Independent Assessment Report

Development Application: 12A and 14-26 Wattle Street, Pyrmont - D/2023/97

File No.: D/2023/97

Figure 37: Section 4.56 modification application: Isometric drawing showing non-compliance with the 27m height standard permitted by clause 4.3 of Sydney LEP 2012 (western view)

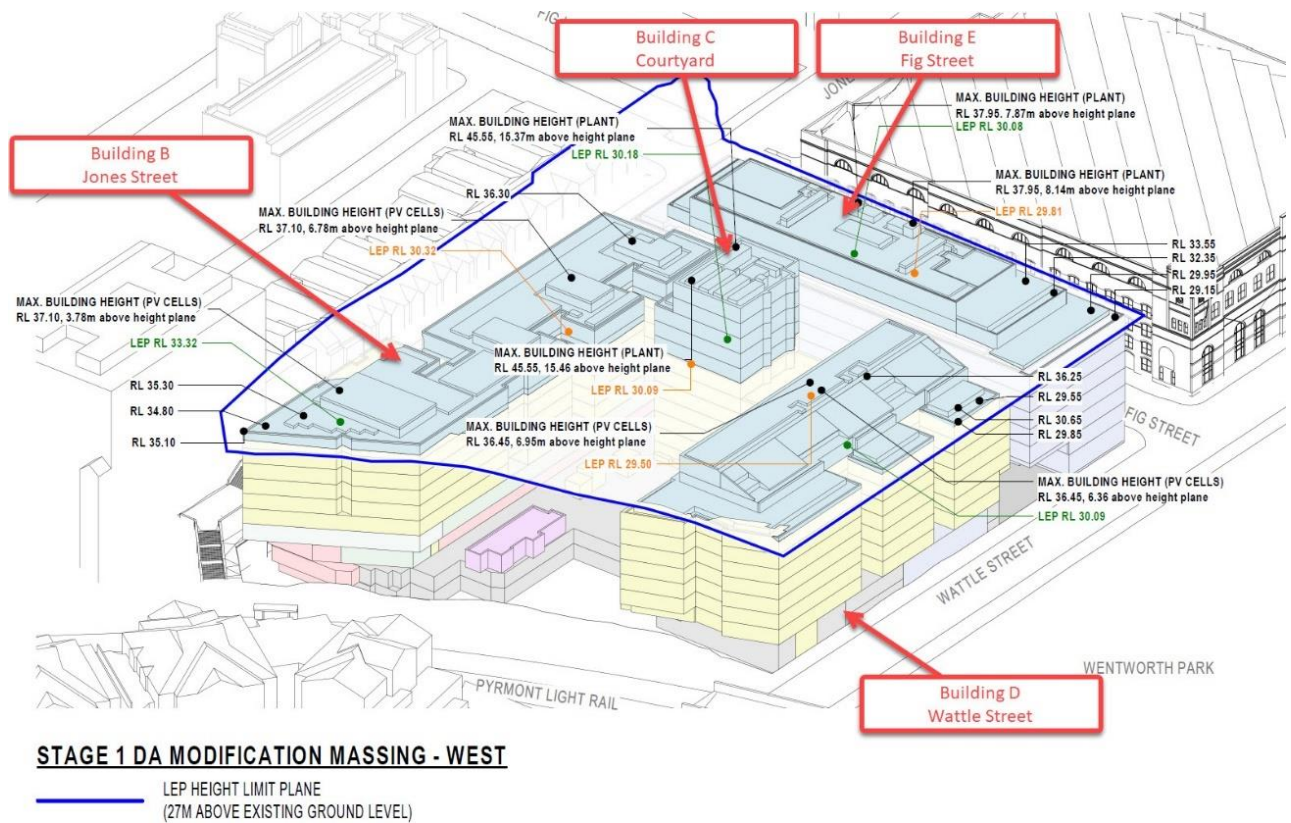
72. **Figures 37** and **38** illustrate the height non-compliances of the development application (noting the name of each building). The design competition winning scheme also exceeded the 29.7m height permitted by clause 6.21D height (see **Figure 39**).

Figure 40: Building C - Courtyard Section: Proposed/modified building envelope

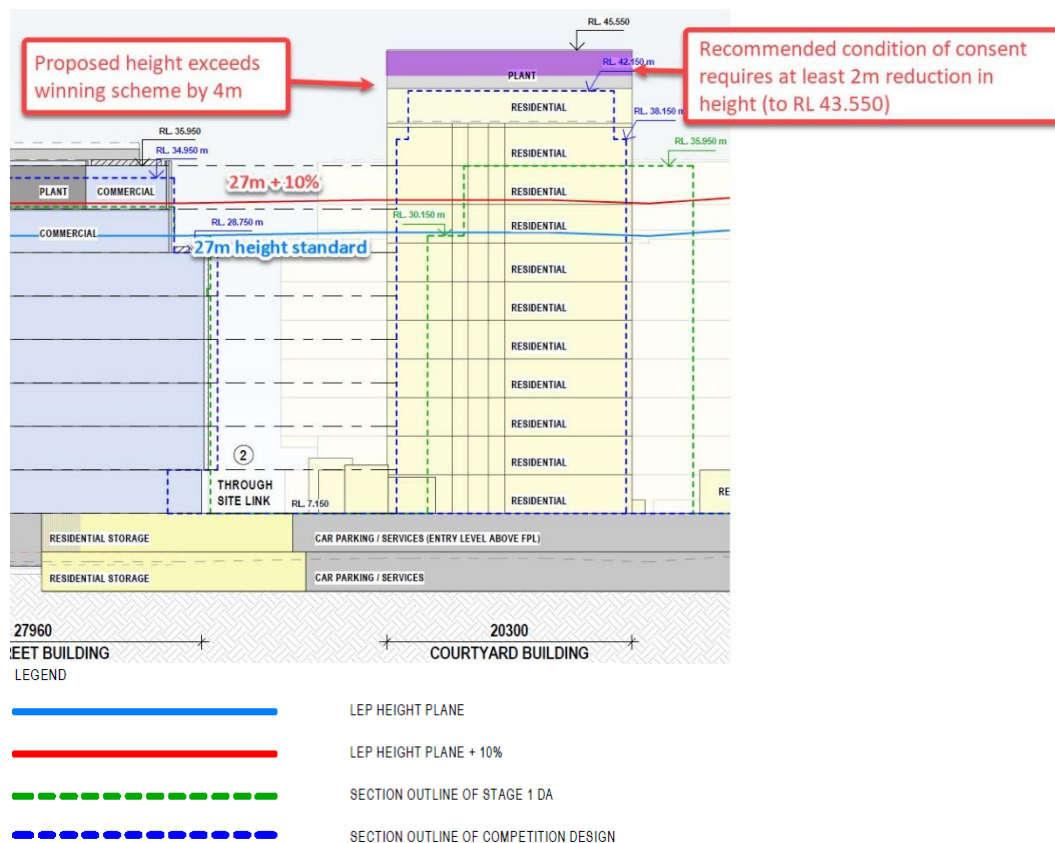
Subject to this condition being imposed on the consent, the height of Building C is considered to be appropriate to the conditions of the site and its context as the increase in height on the Building C accommodates floor space lost by breaking the approved "L" shaped Wattle Street Building. Breaking of the "L" shaped building was supported by the jury for the competitive design process as it provides for an additional through site link and improves residential amenity. Reducing the height of Building C by 2m would also somewhat reduce the amount of additional overshadowing to Wentworth Park (see Discussion section under the heading Overshadowing).

Figure 40 below illustrates a section of proposed Building C showing the 27m height standard (shown in light blue), the 29.7m height standard including 10% additional height (shown in red), the original concept consent envelope (shown in green dash), the design competition envelope (shown in blue dash) and the recommended 2m reduction in height.

Figure 41: Building B - Jones Street: Shadow diagram at 3pm in midwinter

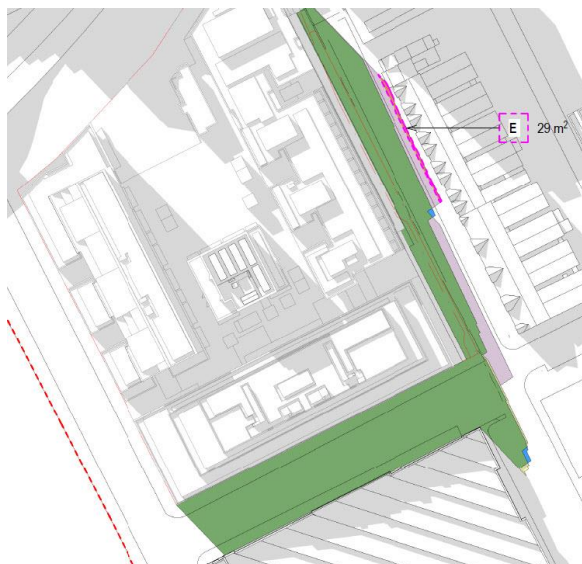
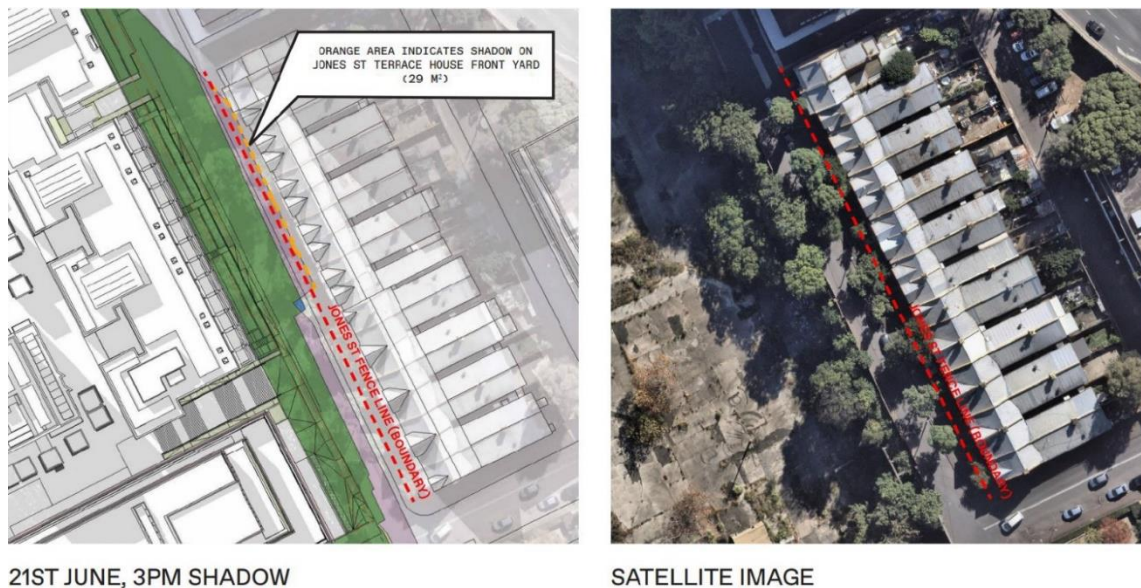
Building B - Jones Street will overshadow the roadway of Jones Street and for a short time and the front yard of several Jones Street terraces (29m² at 3pm in midwinter, Labelled with an "E" on **Figure 41**). An assessment of compliance with the relevant solar access controls in Sydney DCP 2012 follows:

- (i) Sydney DCP 2012 s. 4.1.3.1 Solar access states that neighbouring dwellings are to achieve a minimum of 2 hours direct sunlight between 9am and 3pm on 21 June onto at least 1m² of living room windows and at least 50% of the minimum amount of private open space. As the increase in height to Building B - Jones Street would not cast any additional shadow onto any living room windows, the east facing private open space at the rear of the Jones Street terraces or the Harbour Mill Apartments, the modified development complies with this solar access control.
- (ii) Sydney DCP 2012 s. 3.1.4 Public open space states that 50% of the total area of a park is to receive sunlight for 4 hours from 9am to 3pm on 21 June. As the increase in height to Building B - Jones Street would not overshadow Fig Street Park or Wentworth Park, the modified development complies with this solar access control.

Figure 43: Building D - Wattle Street, Building C - Courtyard and Building E - Fig Street: Shadow diagram at 10am in midwinter

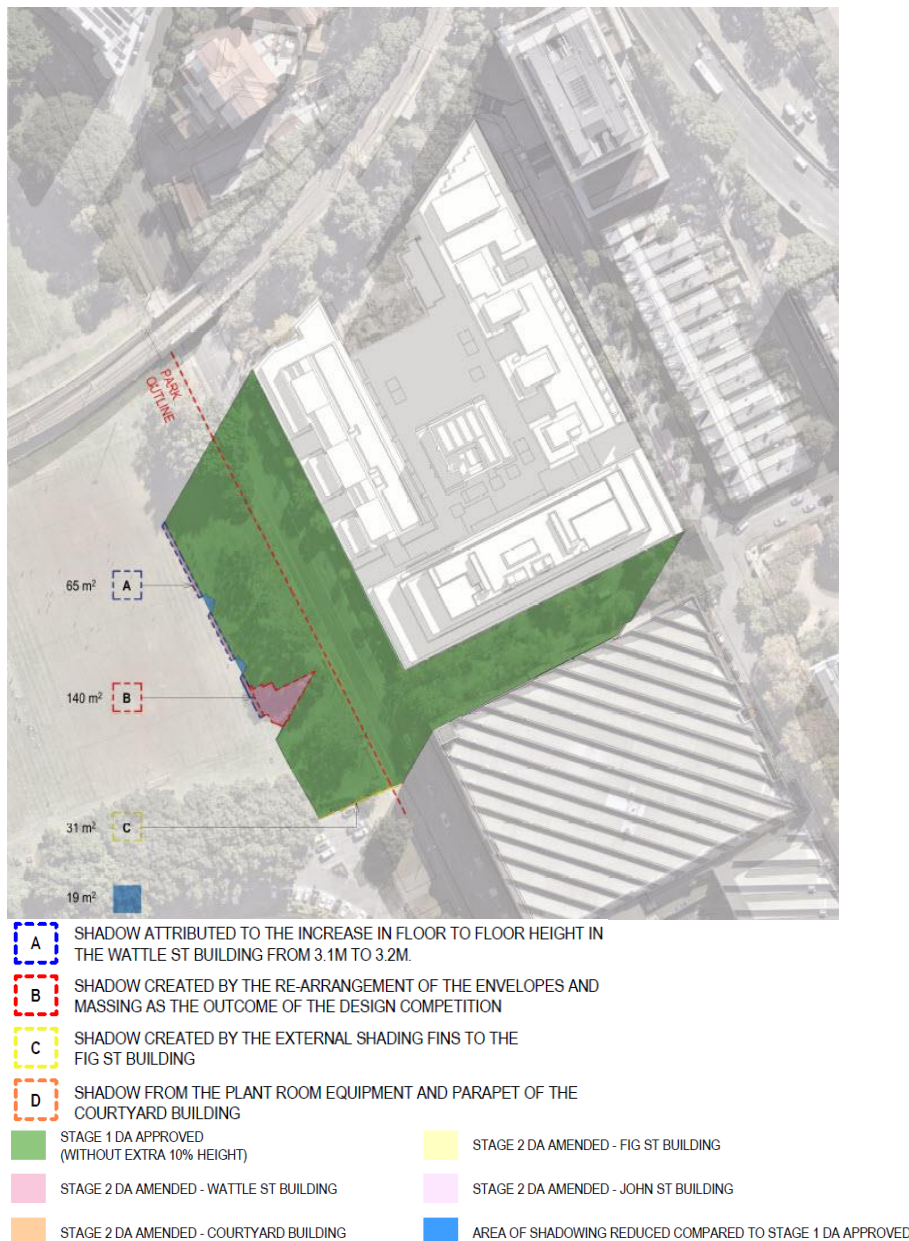
External shading fins on Building E - Fig Street will cast a small additional shadow onto Wentworth Park (11m² at 9am, 31m² at 10am and 1m² at 11am in midwinter) (Labelled with a "C" on the 10am shadow diagram at **Figure 43**). An assessment of compliance with the relevant solar access controls in Sydney DCP 2012 follows:

- (i) Sydney DCP 2012 s. 4.1.3.1 Solar access states that neighbouring dwellings are to achieve a minimum of 2 hours direct sunlight between 9am and 3pm on 21 June onto at least 1m² of living room windows and at least 50% of the minimum amount of private open space. The increase in height to Building E - Fig Street would not overshadow any neighbouring dwellings.
- (ii) Sydney DCP 2012 s. 3.1.4 Public open space states that 50% of the total area of a park is to receive sunlight for 4 hours from 9am to 3pm on 21 June. The small additional shadow cast onto Wentworth Park from fins to Building E - Fig Street does not compromise compliance with this control.

Figure 44: Assessment of compliance with ADG Objective 3F-1 separation distances showing proposed privacy protection measures

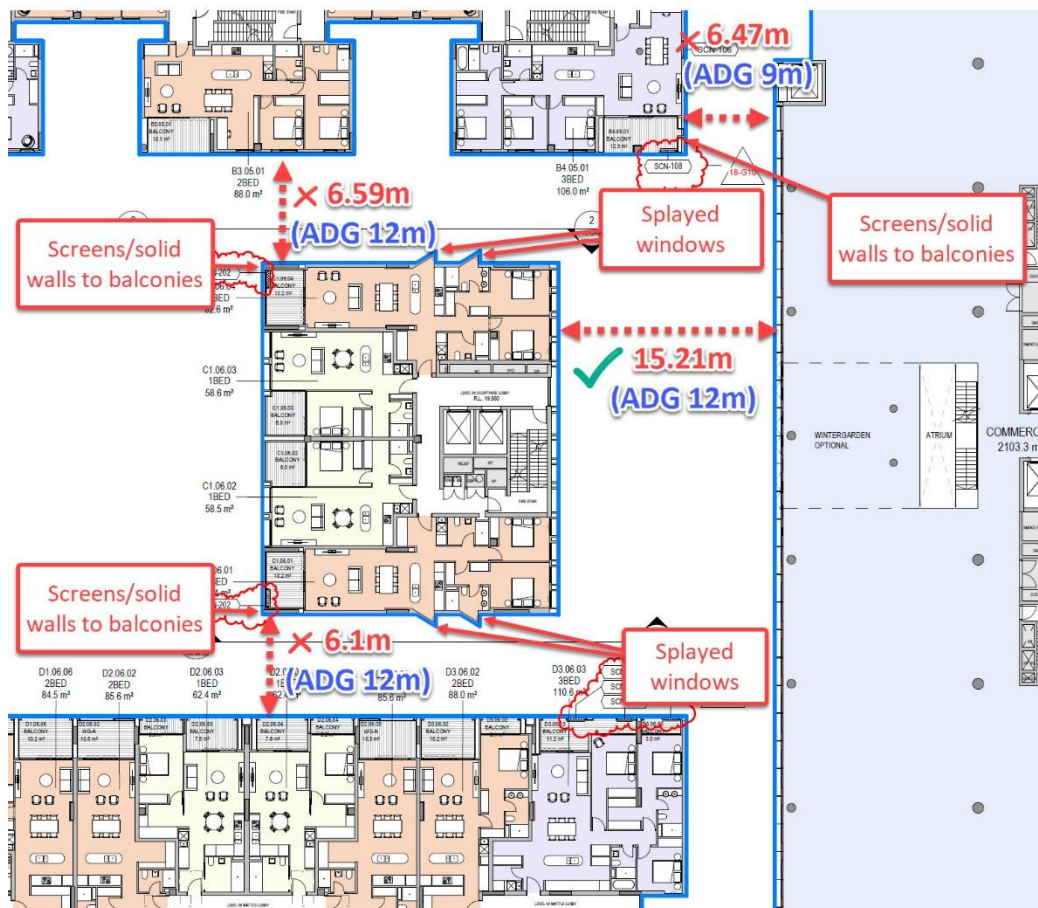
- Have windows offset from opposite façade.
94. Consistent with this notation, the architectural plans submitted with the development application provide appropriate privacy protection measures in the locations where building separations do not meet the ADG design criteria. **Figure 44** illustrates some of the proposed privacy protection measures including splayed windows, screens, solid balcony walls to Building C - Courtyard and other privacy treatments such as louvred screens on the northern side of Building E - Fig Street (commercial). Additional privacy protection measures where non-compliant separations are proposed include operable louvred screens to Building B - Jones Street and Wattle Building D - Wattle Street.

Figure 45: Examples of integrated plenums

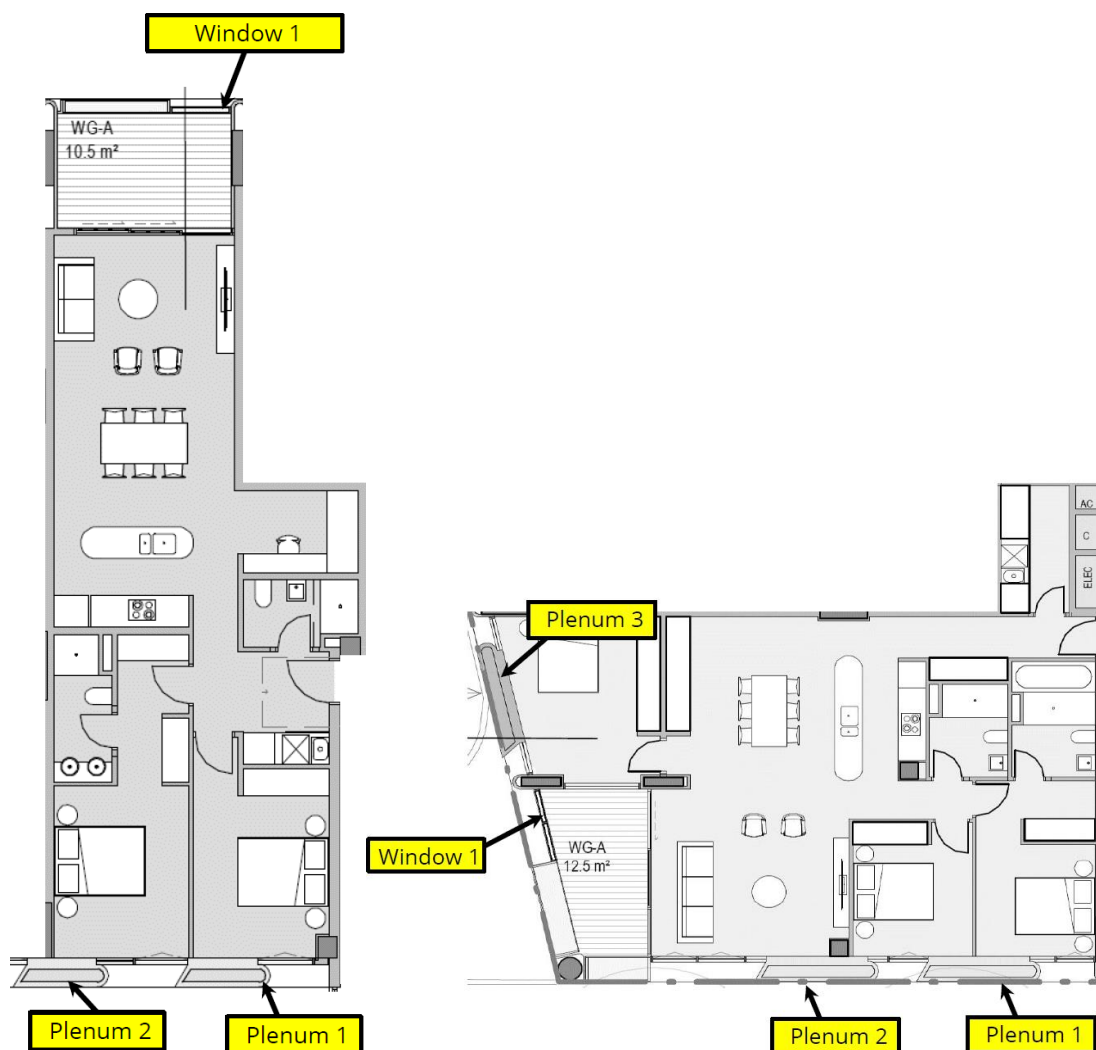
99. Example plenums are illustrated at **Figure 45**. The architectural plans include plenum details. Both the acoustic report and natural ventilation report will be approved as part of the consent to ensure that plenums are constructed and installed in accordance with the specific details in approved reports.

Figure 46: Tree retention value plan showing trees recommended for retention by Council's tree management unit

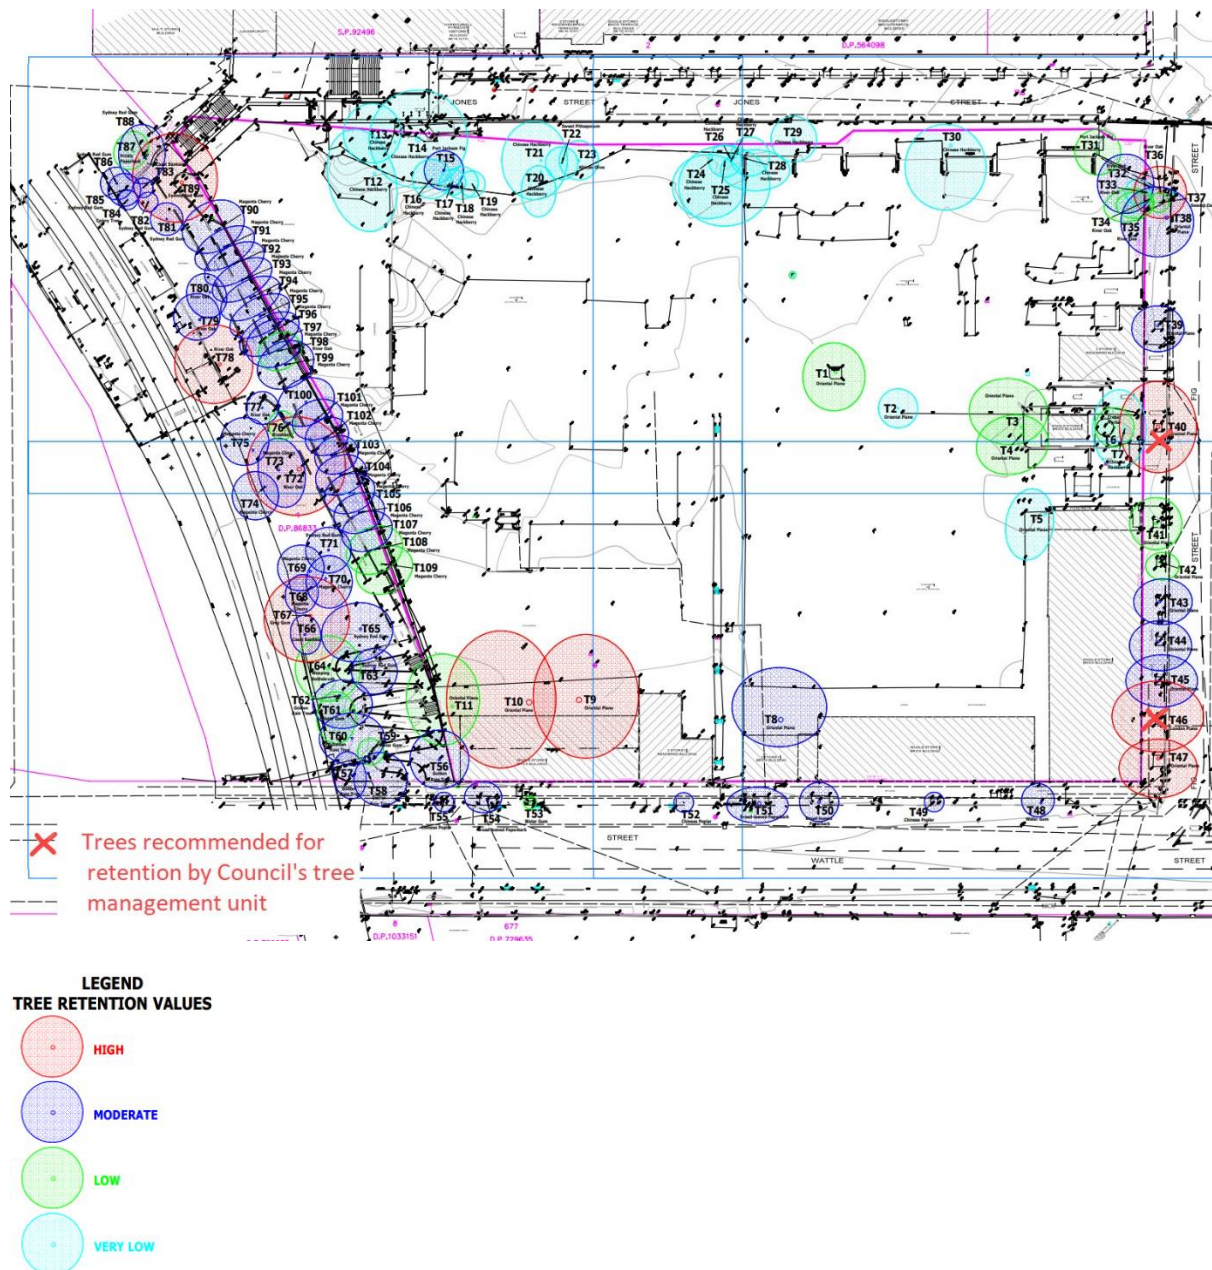
Retention value	Tree numbers	Tree management unit comment
Low retention value	<p>Trees 33, 34, 35 and 98 (<i>Casaurina cunninghamii</i> River Oak), 37 (<i>Casaurina glauca</i> Swamp Oak), 7, 12, 13, 14, 16, 17, 18, 19, 20, 21, 24, 25, 26, 27, 28, 29 and 30 (<i>Celtis sinensis</i> Chinese Hackberry), 31 (<i>Ficus rubiginosa</i> Port Jackson Fig), 6 (<i>Lagerstomia indica</i> Crepe myrtle), 23 (<i>Olea europaea</i> African Olive), 22 (<i>Pittosperum undulatum</i> Sweet Pittosperum), 1, 2, 3, 4, 5 and 11 (<i>Platanus orientalis</i> Oriental Plane)</p> <p>Tree 53 (<i>Tristania laurina</i> Water Gum) Street Tree Removal is supported. Tree to be replaced with advanced species (<i>Weeping Lilly Pilly</i> <i>Waterhousea floribunda</i> Green Avenue) in accordance with the City of Sydney Street Tree master Plan 2023</p> <p>33 trees (including 1 street tree)</p>	The tree removals are supported.
Medium retention value	<p>Tree 8 (<i>Platanus orientalis</i> Oriental Plane)</p> <p>Tree 15 (<i>Ficus rubiginosa</i> Port Jackson Fig)</p> <p>Tree 32 (<i>Casaurina cunninghamii</i> River Oak)</p> <p>Tree 38, 39 and 40 (<i>Platanus orientalis</i> Oriental Plane)</p> <p>Tree 97 and 99 (<i>Syzygium paniculatum</i> Magenta Cherry)</p> <p>Tree 56 (<i>Koelreutaria paniculata</i> Golden Rain Tree) within the rail corridor</p> <p>Tree 48, 49, 50, 51, 52, 54 and 55 Street trees adjacent to Wattle St.</p> <p>16 trees (including 7 street trees and 3 trees within the rail corridor)</p>	The tree removals are supported.

High retention value	<p>Tree 36 (<i>Casaurina cunninghamii</i> River Oak), Tree 9, 10 and 40* (<i>Platanus orientalis</i> Oriental Plane)</p> <p>Tree 46* (<i>Platanus x acerifolia</i> London Plane)</p> <p>5 trees (including 3 street trees)</p>	Removal of high retention value Trees 40 and 46 (both street trees) is not supported (noted with an *). A condition is recommended requiring retention of these trees.
